# GREATER LONDON AUTHORITY

## Deadline 3 - GLA Sheet 1: Applicant's Response to GLA Relevant Representations

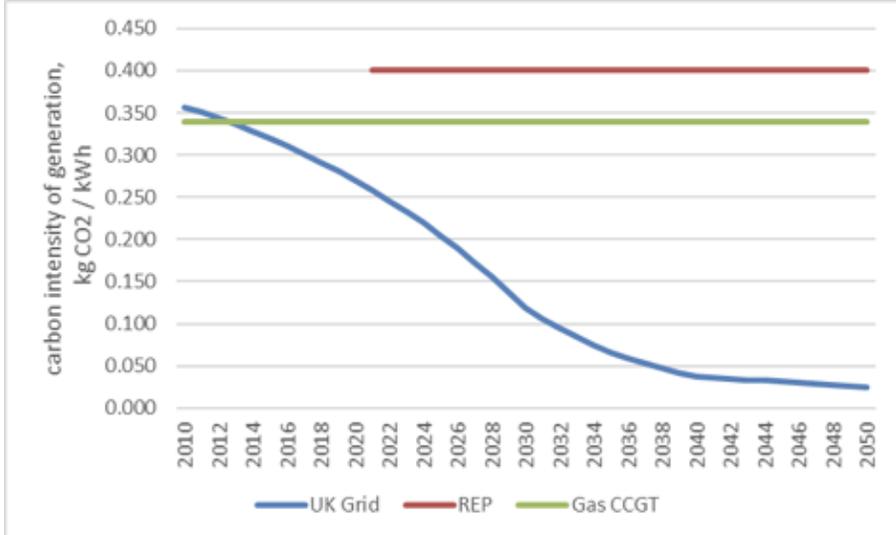
Issue	Applicant's comment	GLA/TFL Comment / action
	<p><i>Municipal Solid Waste (MSW) to landfill by 2035, if a 65% MSW recycling rate is achieved by that same year. The analysis assumes refuse derived fuel (RDF) exports remain at current levels. However, if energy recovery continues to provide a better environmental alternative to landfill, more investment to reduce tonnages of MSW to landfill further would deliver environmental benefits” .</i></p> <p>2.5.13 The full quote shows the full context of the Government's thinking and that it recognises the environmental benefits of energy from waste. In any event, the policy set out in the Resources and Waste Strategy, is to encourage greater private investment in new, modern, efficient energy recovery plant. As demonstrated in the Supplementary Report to the Project and its Benefits Report (7.2.1), that is exactly what REP is delivering. The final quote set out in the GLA's RR, that “no new EFW capacity would be needed”, does not exist. A clear rebuttal from Tolvik Consulting Ltd, the consultancy that prepared that industry report, is provided at Appendix A to the Supplementary Report to the Project and its Benefits Report (7.2.1).</p>	<p>The “no new EFW capacity is needed’ line referenced in the GLA's Relevant Representation relates to the following paragraph from page 78 of the RWS Evidence Annex:</p> <p><i>“Tolvik Consulting Ltd. carried out a similar assessment, bringing together existing reports around Energy from Waste, and concluded that there would not be a gap in incineration capacity in 2030, provided the 65% MSW recycling rate ambition was met (Figure 9 below).”</i></p>
